Exhibit A

Proposed Reliability Standard PRC-025-2 – Generator Relay Loadability

PRC-025-2 - Clean Version

Figure 1: Generation exported through a single radial line.

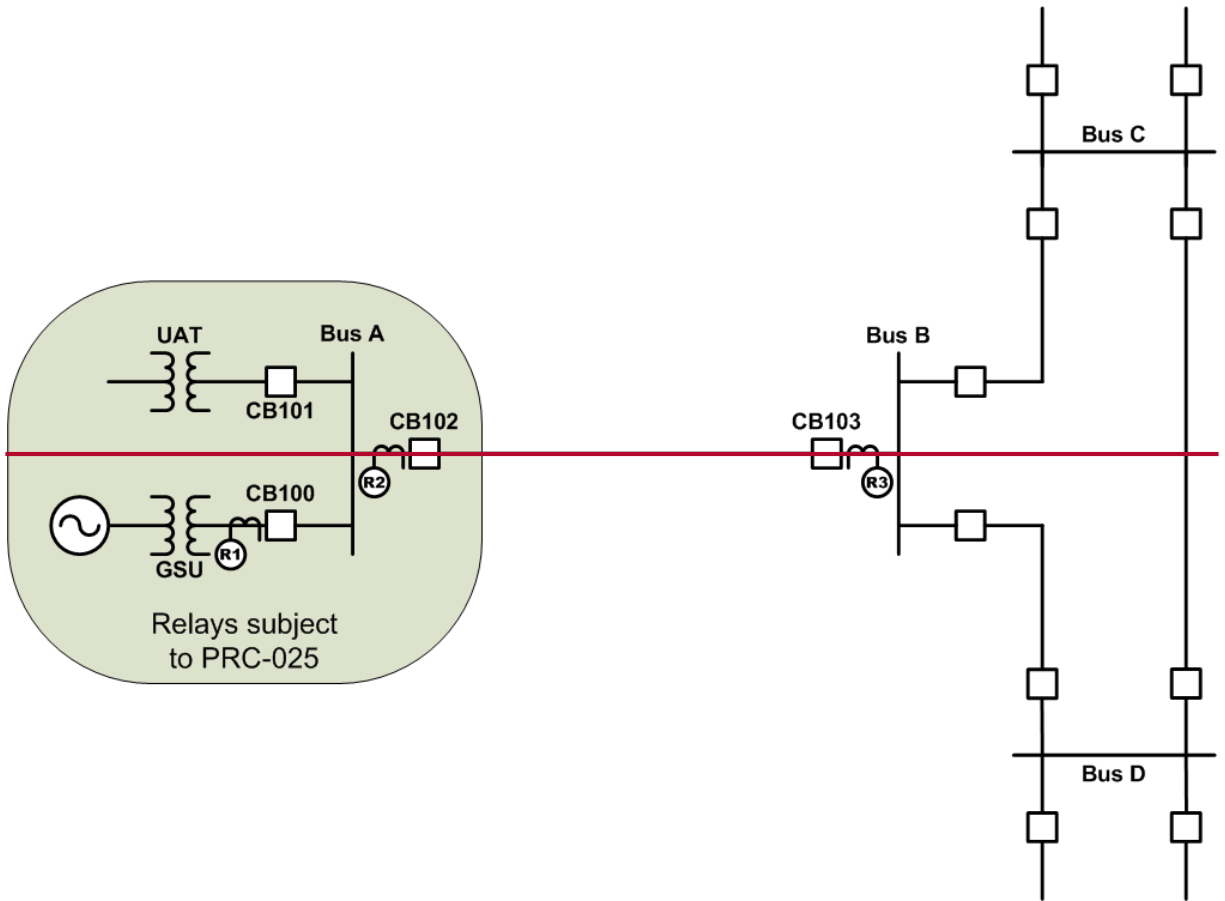
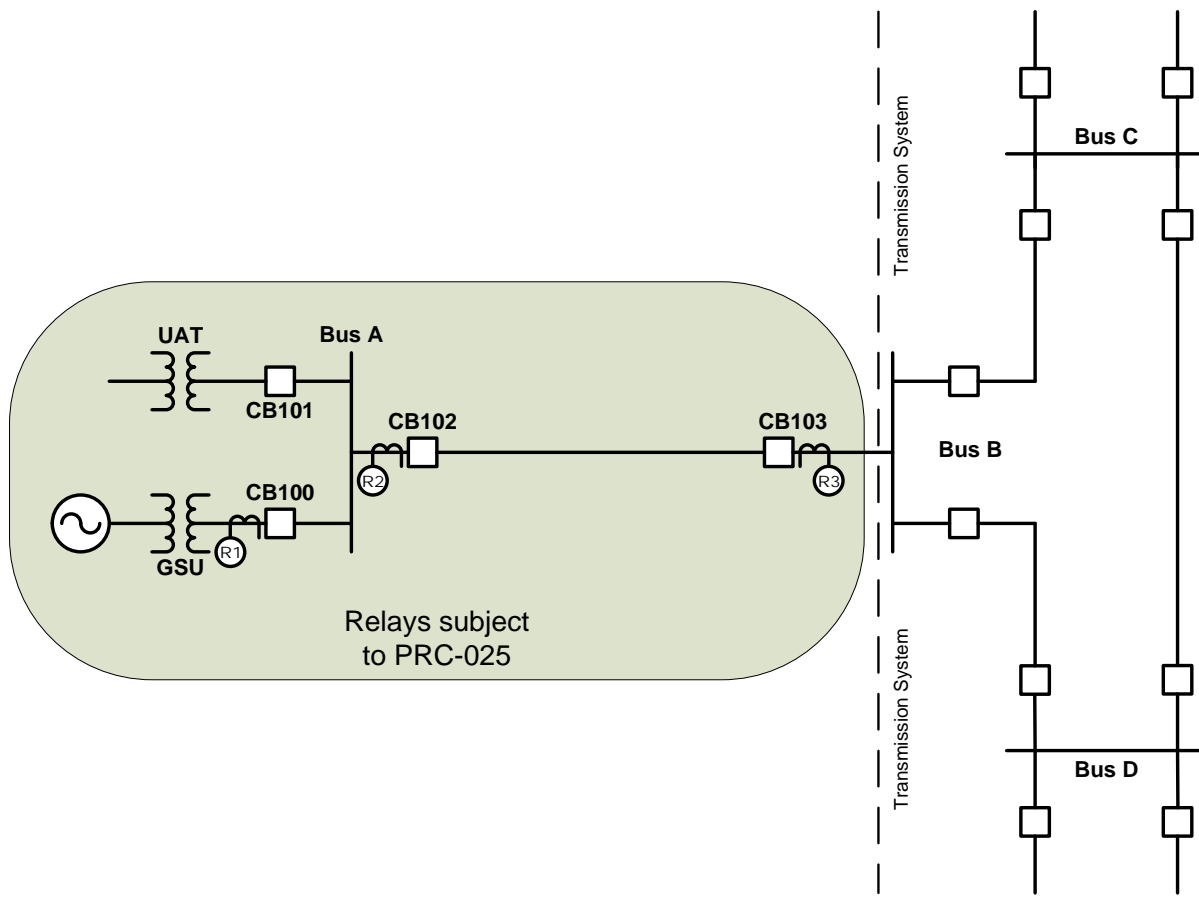
- d. It is not clear that CB103 relay in Figure 1 of the Application Guidelines is applicable to the standard because the Application Guidelines only addresses a directional relay toward the generator plant as not being applicable; however, there are cases where CB103 would be applicable to the standard (e.g., non-directional relays). Provide clarity that would help prevent the overlooking of the CB103 relay as being applicable to the standard, including a potential revision to Figure 1.

- d. Consider clarifying that CB103 relay in Figure 1 of the Application Guidelines is applicable to the standard and correct the figure to show CB103 as also possibly being subject to the standard. The Application Guidelines only addresses a directional relay and that non-directional relays would be applicable to the standard.

Tri-State would like clarification on the phrase "and on the remote end of the line" used in the Relay Type column of Option 14. Looking at the red-lined language under "Figure 1" of the guidelines section, our understanding is that relay R3 is applicable only if it is set with an element directional toward the transmission system or is non-directional. If relay R3 is set directed toward the generator, it is not applicable. If that is the case we recommend splitting up the language between the 2 scenarios and adding a figure to make it clear. As it is currently written, it isn't clear that only the 1st of those scenarios is displayed in Figure 1.

Thank you for your comment. The drafting team has updated Figures 1, 2, and 3 with a demarcation line labeled “Transmission System” for added clarity.

Figure 2: Generation exported through multiple radial lines.

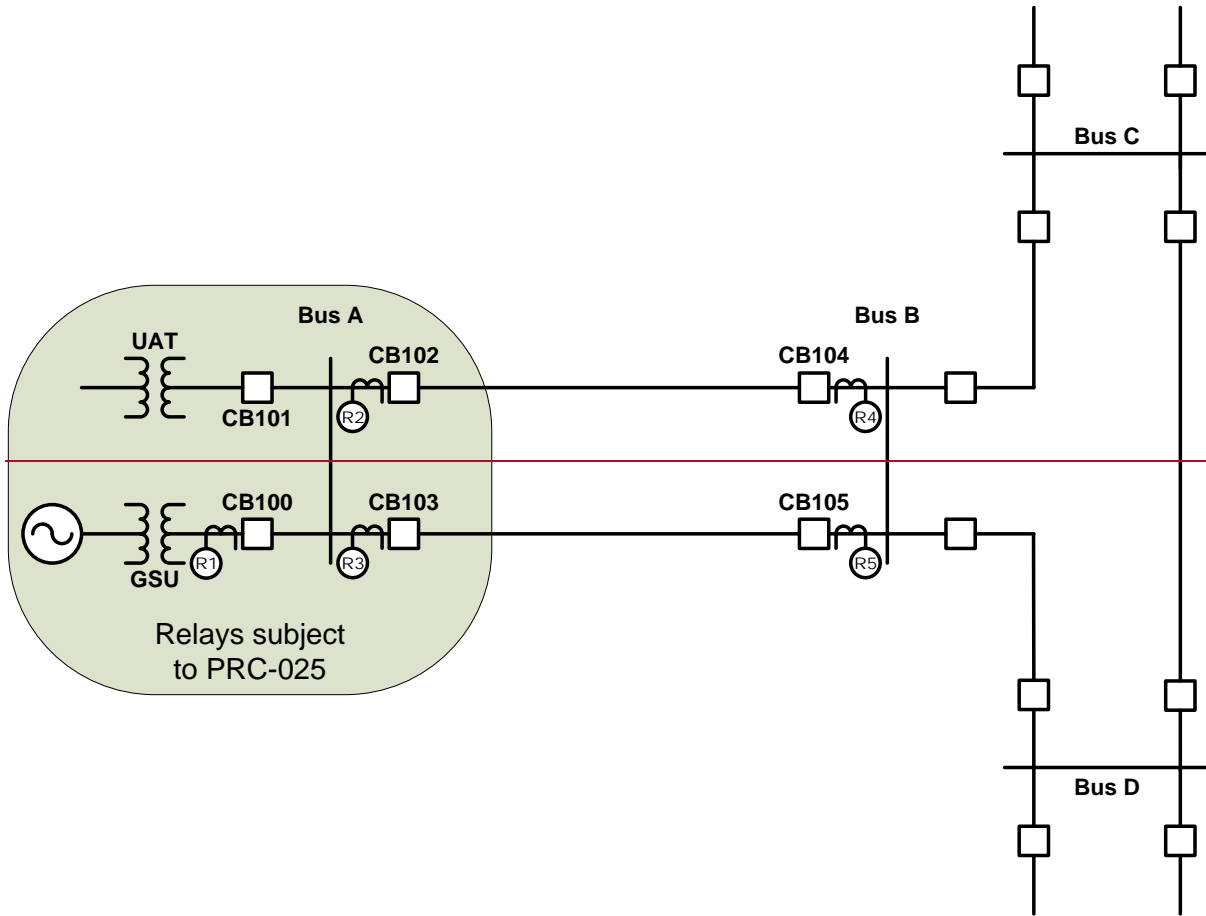
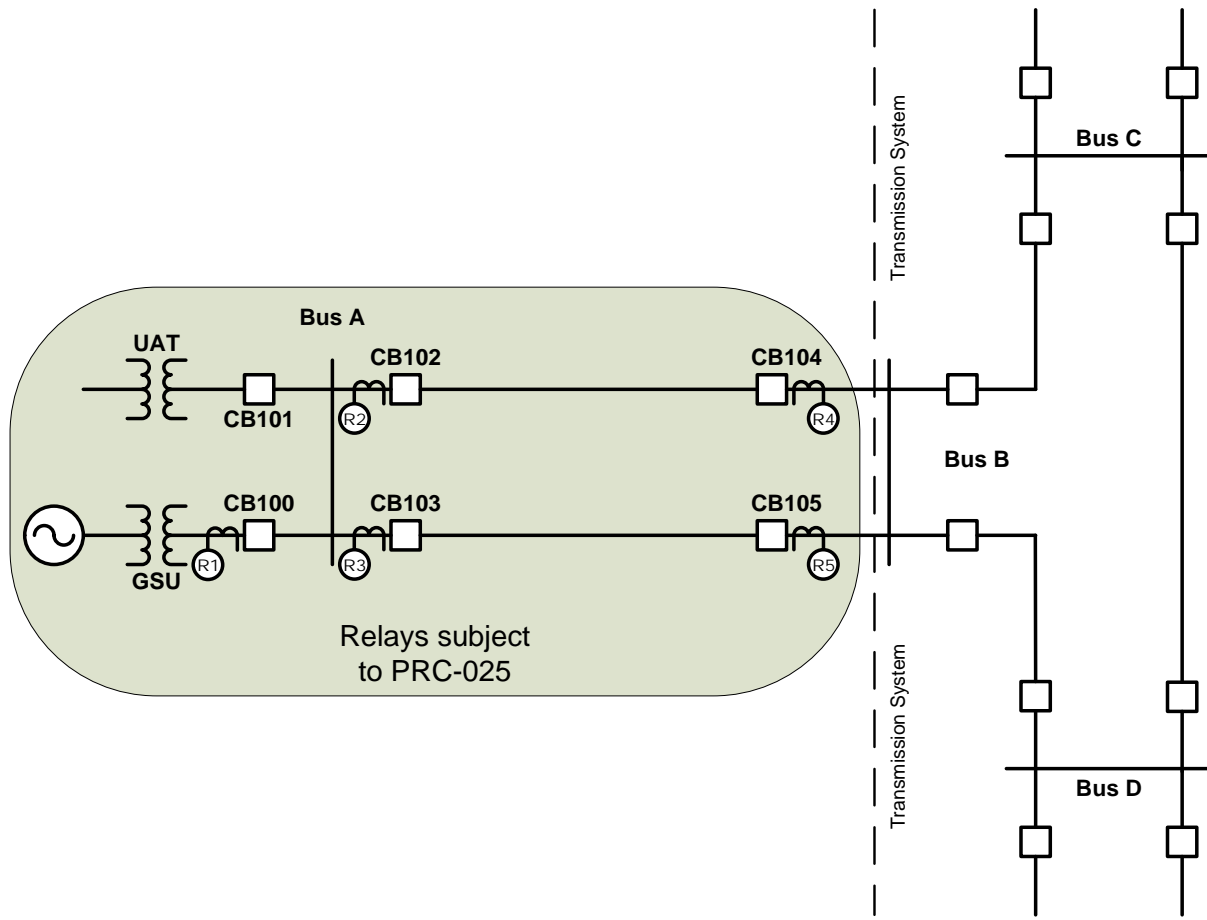
For figure 2, identify that busses B, C, and D and their interconnecting lines as 'the transmission system' for clarity. We believe that this will help clarify that only reverse-looking or non-directional elements are within PRC-025 scope.

Figure 3: Generation exported through a network.

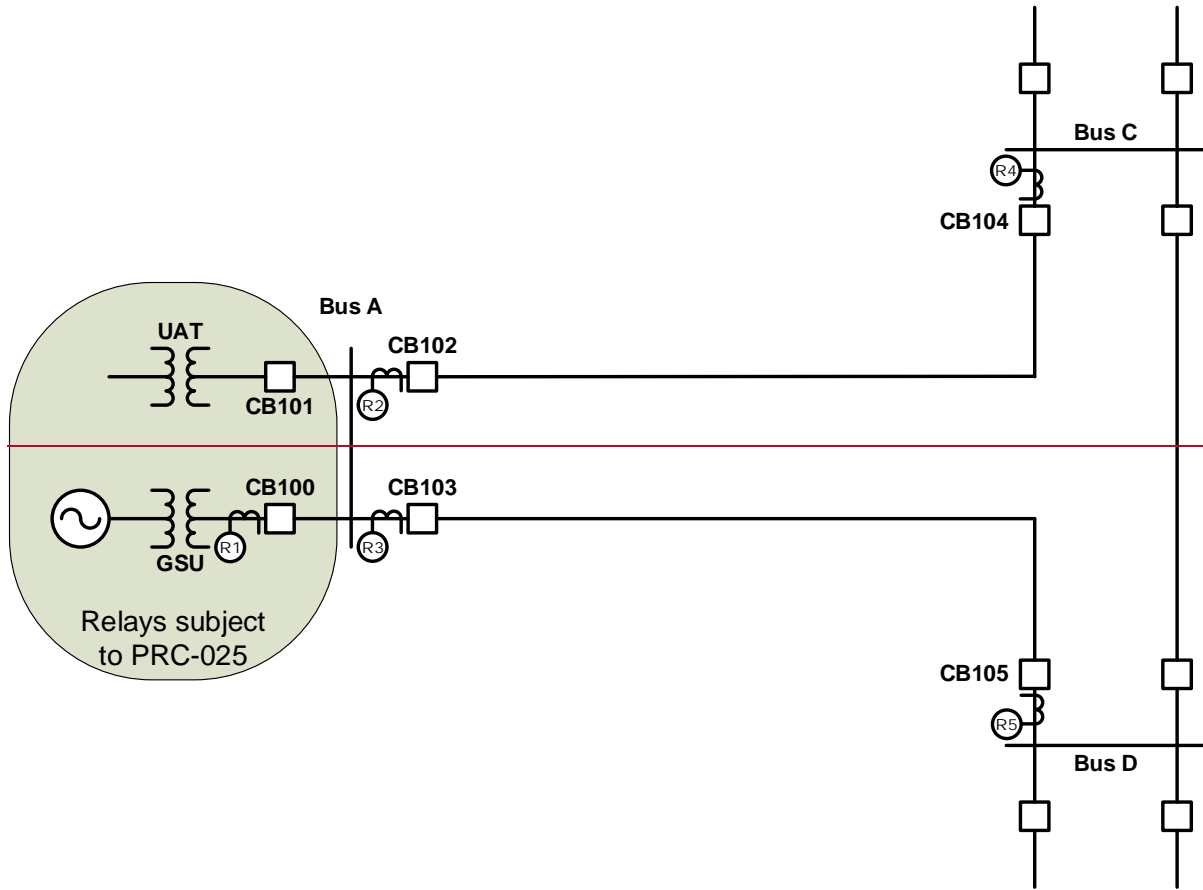
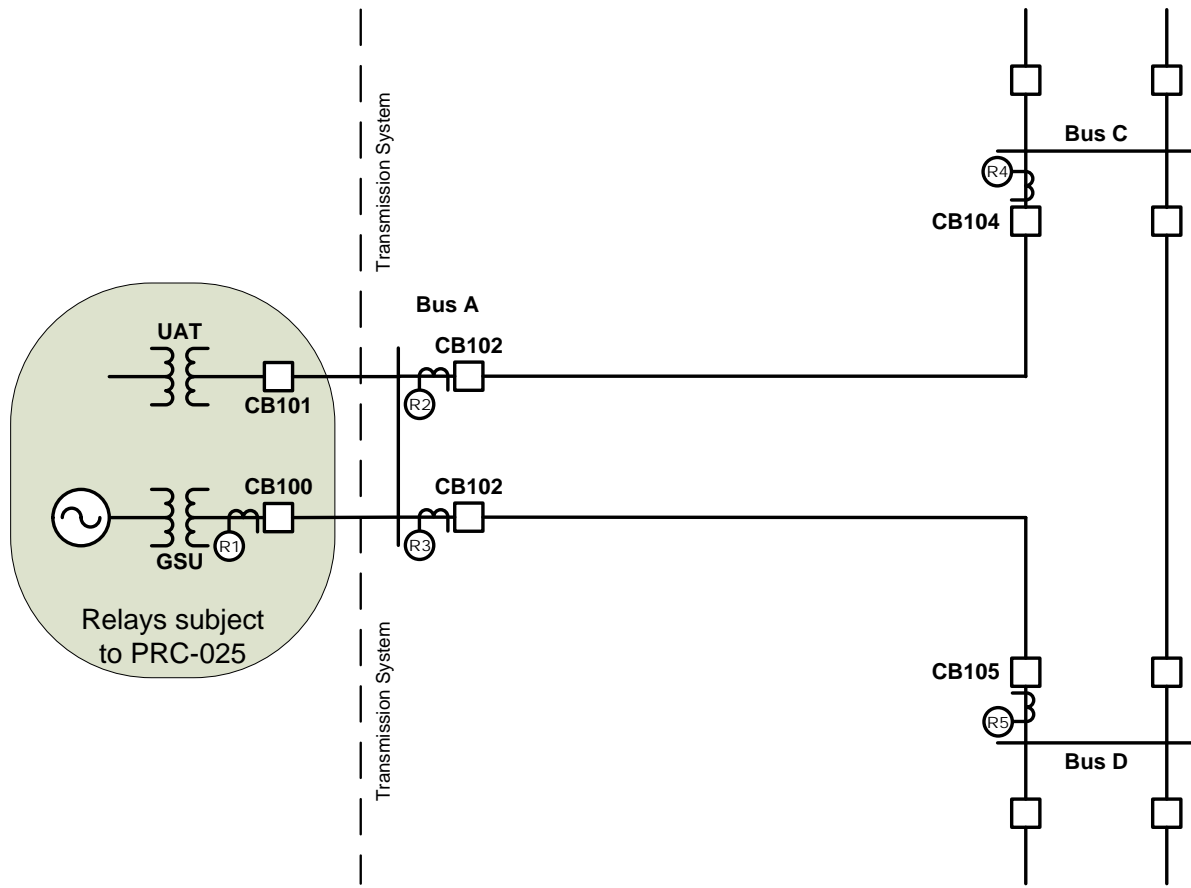
Answer	No
Document Name	
Comment	
<p>Figure 3 of the Guidelines and Technical Basis section discusses the inclusion of collector system protective elements; however, the NERC defined term "Element" specifically excludes collector systems in accordance with the NERC bulk Electric System Definition Reference Document dated April 2014; see page 21 of 85. http://www.nerc.com/pa/RAPA/BES%20DL/bes_phase2_reference_document_20140325_final_clean.pdf</p> <p>Reclamation recommends that the Guidelines and Technical Basis document state that it is an example only and is not enforceable, or remove the discussion on collector system protection elements.</p> <p>If the drafting team intended to include collector system protective elements for zero-defect compliance monitoring and change management, Reclamation recommends the standard be revised to clearly state "PRC-025 collector system" or "PRC-025 collector system relay elements" throughout the standard, including the Applicability Section.</p>

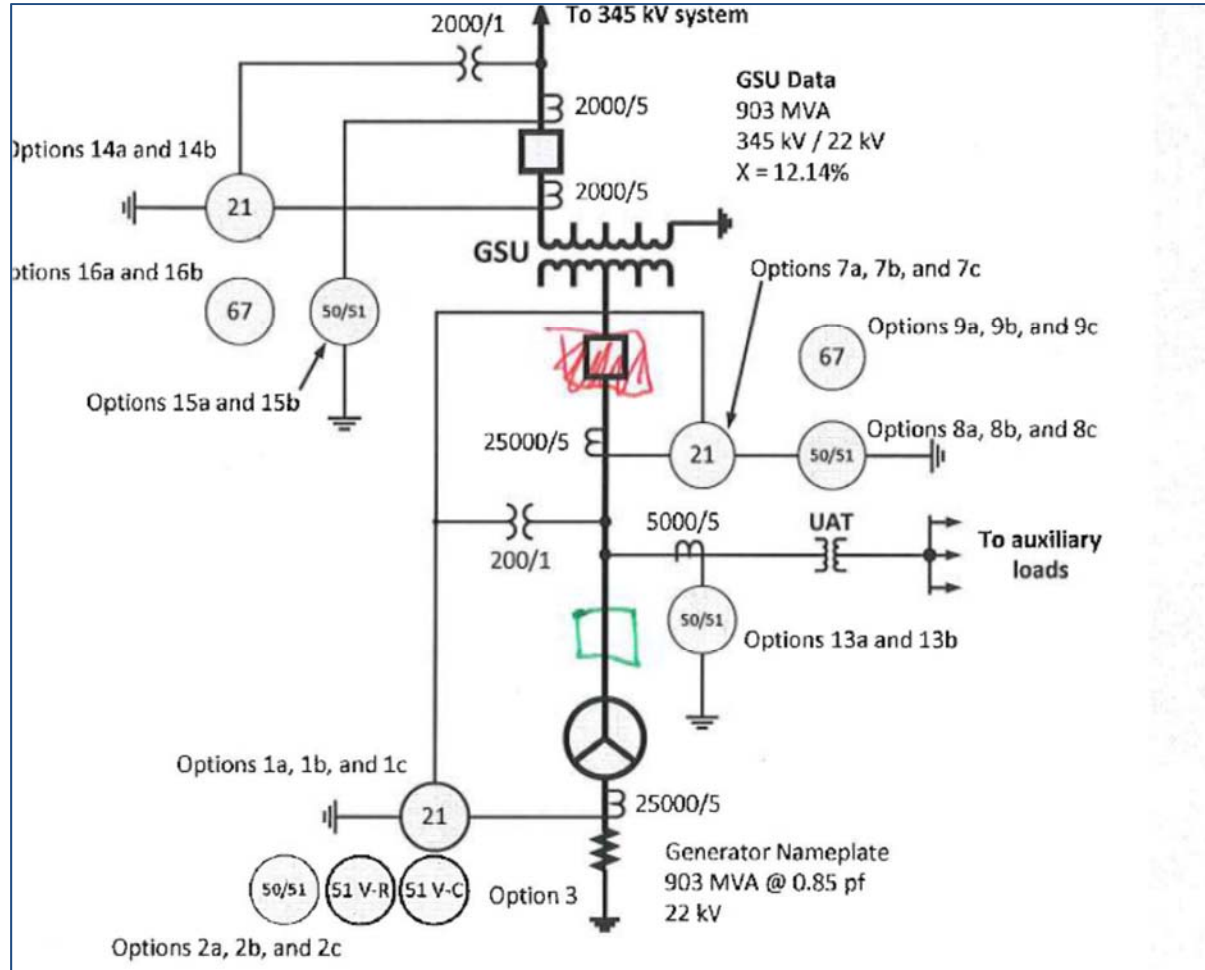
Xcel Energy has concerns that the changes to the "Application" column for Options 7a-7c, 8a-8c, and 9a-9c are somewhat misleading and the description is inconsistent with Figure 5. We do acknowledge that this is partially a carryover issue from PRC-025-1.

The "Application" column for options 7, 8 & 9 describe "Relays installed on the generator side of the Generator step-up transformer..." Figure 5 shows that the current transformers for the load dependent relays to which options 7-9 are applicable are actually applied on the generator or the generator breaker and not specifically on the low side of the GSU. Note that many microprocessor based generator protection relays allow you to select the signal source for the current input to the 21 function such that either neutral or line side current transformers may be used for the current signal input to the 21 device associated with the generator. In other words, not all generator load dependent relays are fed neutral side current transformers. From this perspective, it would be unclear whether the entity should be using option 1a-1c or option 7a-7c for evaluating the loadability of the 21 function or options 2a-2c or option 8z-8c for the 50/51 functions.

Note that on Figure 5, the location of the generator breaker relative to the generator bus tap to the UAT is incorrect for most typical applications. In most applications when a generator breaker is provided, it will be on the generator bus between the generator and the bus tap to the UAT so that the UAT remains in service from the GSU when the generator breaker is open and the generator is offline. There would be operational value in a generator breaker between the UAT tap and GSU LV winding as shown in Figure 5. By moving the location of the generator breaker to the correct location between the generator and UAT bus tap on Figure 5, all inconsistency would be eliminated and would greatly improve the clarity of the differences between options 1 vs. 7 and 2 vs. 8. See attached file for markup of Figure 5.

The representation of the breaker in Figure 5 is for illustration and may not be representative of all configurations.
